Re: Woodburn Farms Ltd. P1175-01

I refer to previous Agency correspondence of 14th August last. Please find detailed below the response to the issues raised.

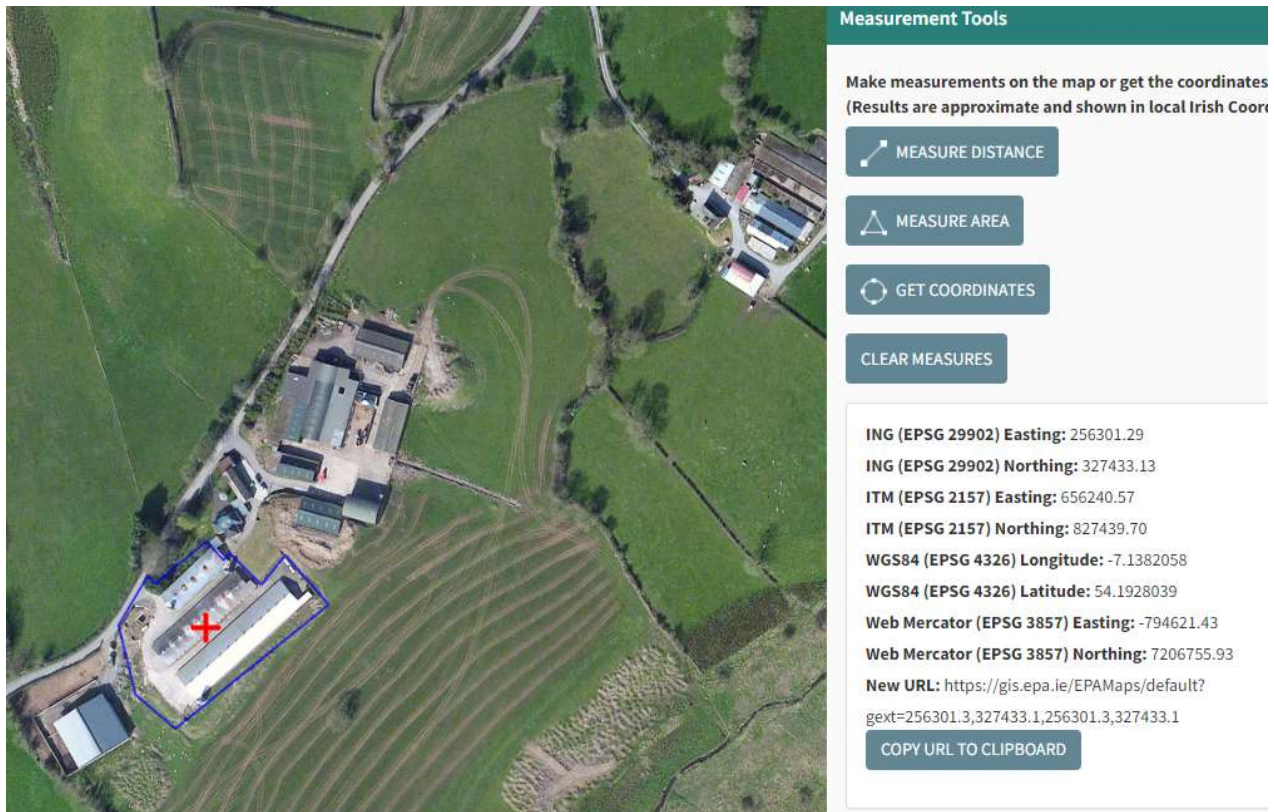
- 1. The grid reference provided for the site appears to be incorrect. Supply the correct grid reference for the site.**

ING (EPSG 29902) Easting: 256301.29
ING (EPSG 29902) Northing: 327433.13
ITM (EPSG 2157) Easting: 656240.57
ITM (EPSG 2157) Northing: 827439.70
WGS84 (EPSG 4326) Longitude: -7.1382058
WGS84 (EPSG 4326) Latitude: 54.1928039
Web Mercator (EPSG 3857) Easting: -794621.43
Web Mercator (EPSG 3857) Northing: 7206755.93
New URL: <https://gis.epa.ie/EPAMaps/default?gext=256301.3,327433.1,256301.3,327433.1>
COPY URL TO CLIPBOARD
